SPRC
February 27, 2023

SPLN22-00002 Wells Fargo/Verizon

General Land Use Plan Amendment, New Site Plan

3140 Washington Blvd. & 1025 N. Irving St.(RPC# 19-004-012; 19-004-005; 19-004-011;
19-004-008)

CONCEPTUAL DESIGN SOLUTION: METAL MESH PANELS OVER ACOUSTICAL ASSEMBLY

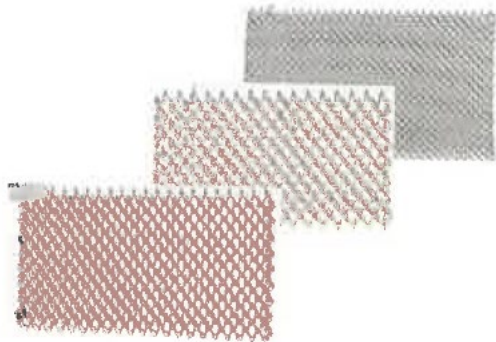
- Verizon Building proposes screening (and acoustical baffles on top) of rooftop generators on 1970s building;
- Verizon proposes additional similar screening of mechanical equipment as needs arise in the future

- Banded colors on the acoustical panels reference the bands of windows on the existing building
- Variation in color of the acoustical panels dissolve the sense of mass
- Metal mesh fabric panels mounted forward of acoustic screen
- Screen begins 8-10 feet above ground
- Potential light fixtures mounted at bottom of screen to illuminate walk path at night

Irving Street (Right)
Hudson Street (Below)

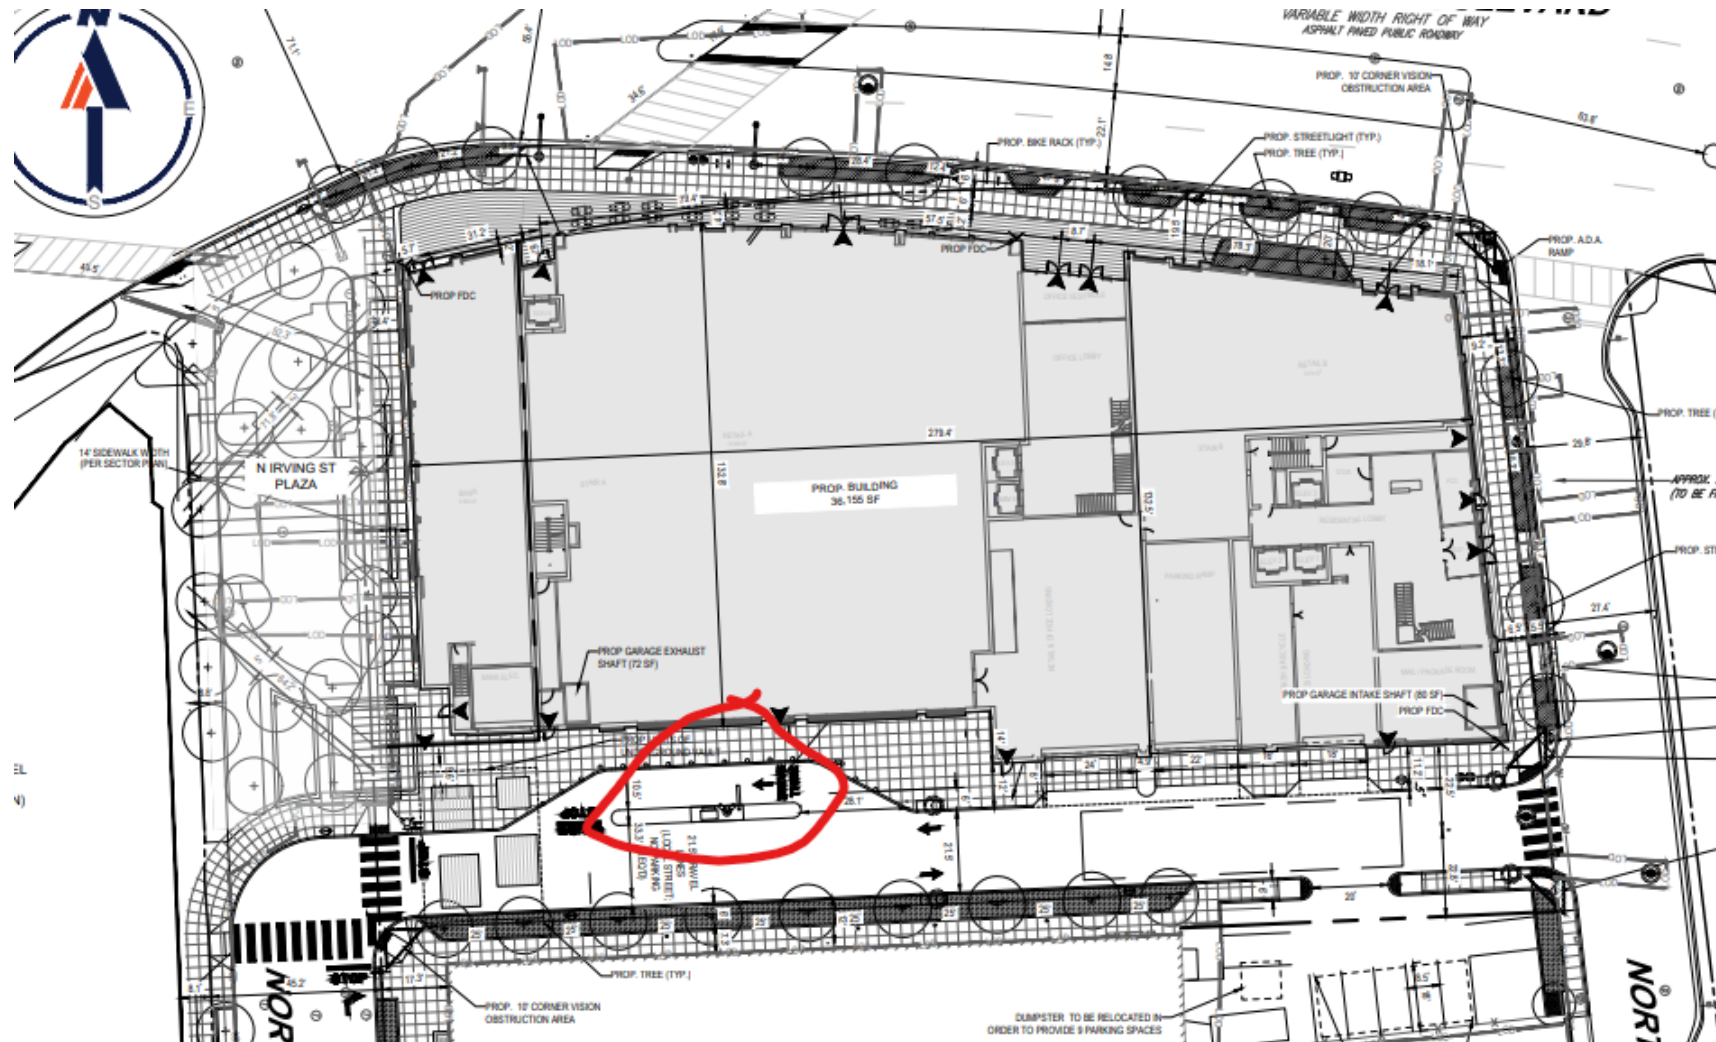
- Staff would like to see Verizon and developer propose idea for improvement of the '70s addition
